City of Portland, Maine - Building or Use Permit Application
389 Congress Street, 04101 Tel: (207) 874-8703, Fax: (207) 874-8716

Permit No: 01-0252	Issue Date: APR - 4	CBL: 048 E021001
-----------------------	------------------------	---------------------

Location of Construction: 541 Cumberland Ave unit #4	Owner Name: Brick House Properties Inc	Owner Address: Po Box 175	Phone: 207-781-5008
Business Name: Brickhouse Properties	Contractor Name: no contractor/self	Contractor Address: n/a n/a	Phone: 2077815008
Lessee/Buyer's Name: Andy Hyland	Phone: 207-781-5008	Permit Type: Alterations - Dwellings	Zone: R-6

REASON FOR PERMIT: Interior Reno. Unit # 4

BRICK HOUSE
 541 CUMBERLAND
 #4 MARCH 2001

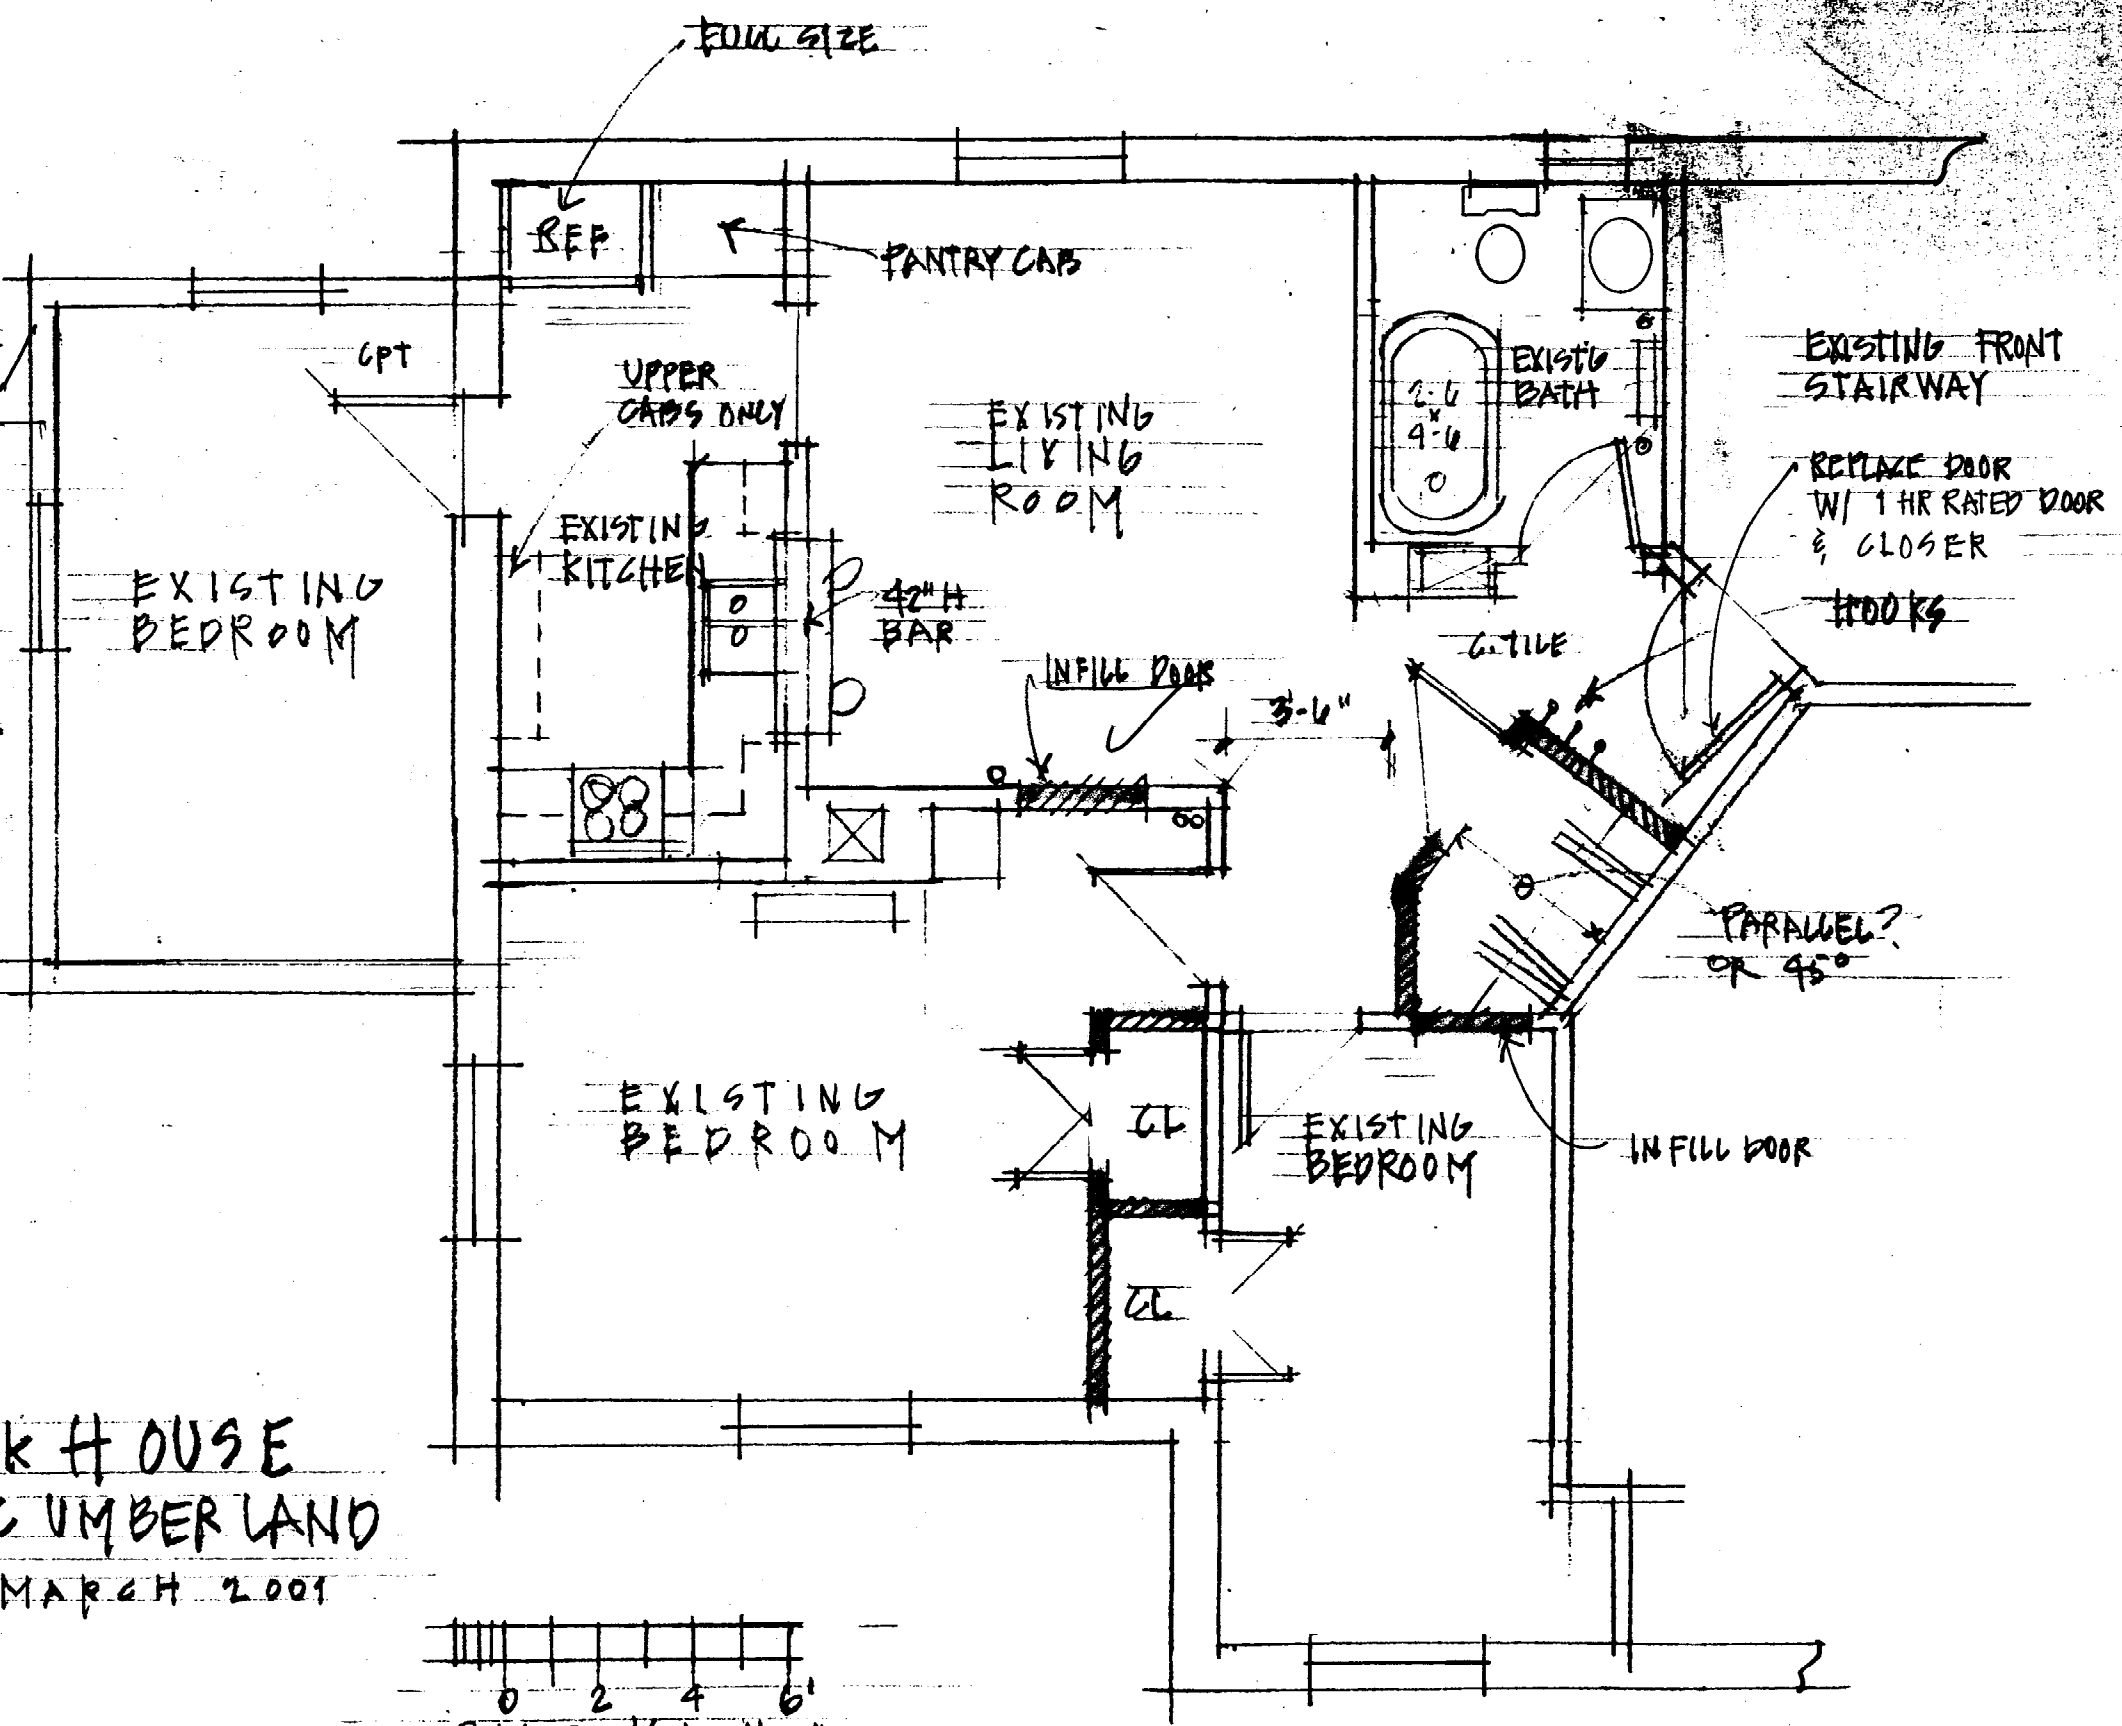
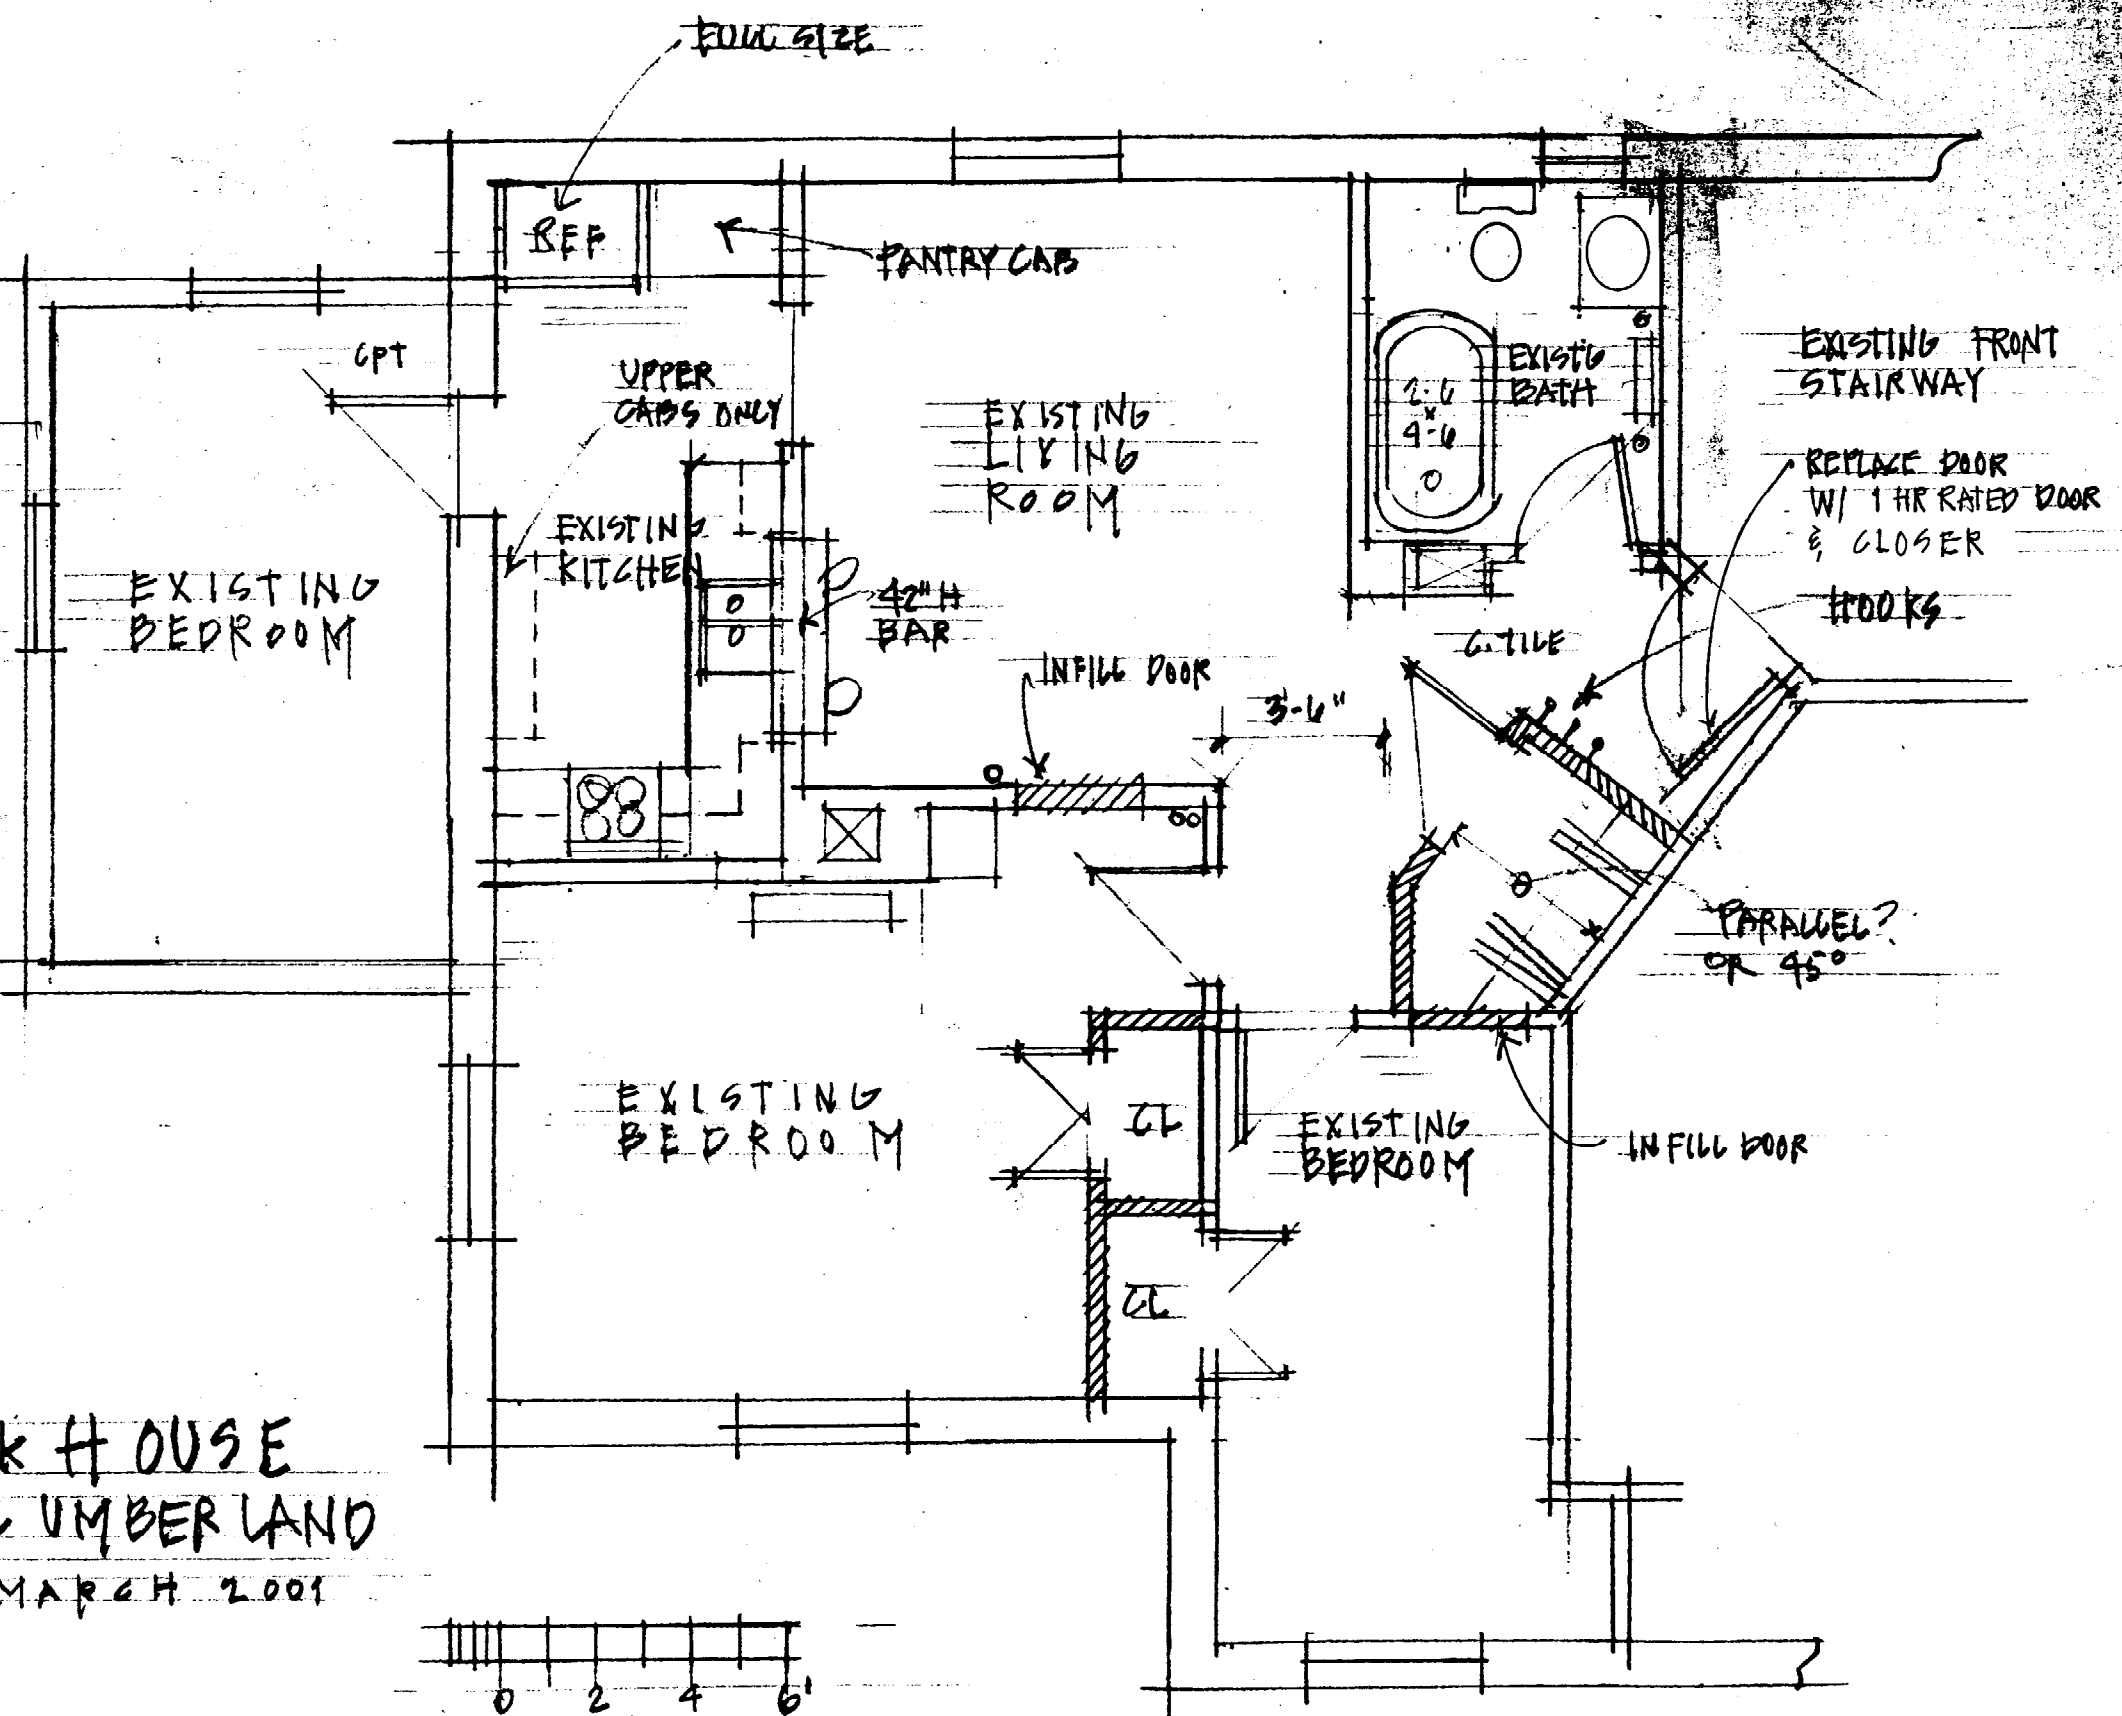
3/26/01 checked Framing and Plumbing, ok to close
except need Fire Protection around plumbing/electrical
Chase JB

4/23/01 Inspected chase - still needs Fire protection - has
access panel to plumbing - ok to protect at floor. JB

This permit is being issued with the understanding that the following conditions shall be met: 1, 18, 28, 20, 32

17. Each apartment shall have access to two (2) separate, remote and approved means of egress.
18. All vertical openings shall be enclosed with construction having a fire rating of at least one (1) hour, including fire doors with self closure's.
